Access Compliance Report

Public Rights-of-Way

(Curb Ramps)

Intersection ID: 32118	Main Street: COLE_MILL_RD	Cross Street: DUNDALK_RD	Location: S
ADA ID: B7058FB7F301	Ramp Type: PerpDiag	Initial Pass/Fail: Fail	Overall Compliance: No
		Severity Score: 47.5

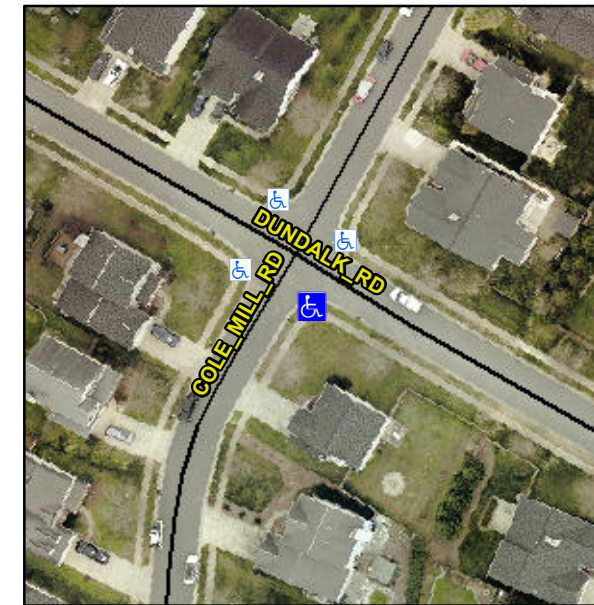
Not Found, R304.5.1, R304.5.3

Compliance	Description	Data	Compliance	Description	Data
N/A	Ramp Length (in)	49.0	Yes	Ramp Slope (%)	5.7
No	Ramp Width (in)	31.5	No	Ramp XSlope (%)	5.8
N/A	Flare Type LT	N/A	N/A	Flare Type RT	N/A
N/A	Flare Slope LT (%)	N/A	N/A	Flare Slope RT (%)	N/A
N/A	Flare Traversable LT?	N/A	N/A	Flare Traversable RT?	N/A
N/A	Landing Length (in)	N/A	N/A	DWS Provided?	N/A
N/A	Landing Width (in)	N/A	N/A	DWS Contrast?	N/A
N/A	Landing Slope (%)	N/A	N/A	DWS Length (in)	N/A
N/A	Landing X Slope (%)	N/A	N/A	DWS Full Width?	N/A
N/A	Landing Curb? (Y/N)	N/A	N/A	DWS Offset (in)	N/A
N/A	Shared Landing?	N/A			
N/A	Gutter Ponding?	N/A	N/A	Gutter Slope (%)	N/A
N/A	Gutter Lip Ht (in)	N/A	N/A	Gutter X Slope (%)	N/A
N/A	Painted X Walk1?	No	N/A	Painted X Walk2?	No
	X Walk 1 Direction	To NE		X Walk 2 Direction	To NW
N/A	X Walk 1 Width (in)	N/A	N/A	X Walk 2 Width (in)	N/A
	X Walk 1 Slope (%)	2.0		X Walk 2 Slope (%)	5.0
	X Walk 1 X Slope (%)	4.0		X Walk 2 X Slope (%)	1.5

Remove & Replace Curb Ramp With Two New Directional Ramps or Equivalent.
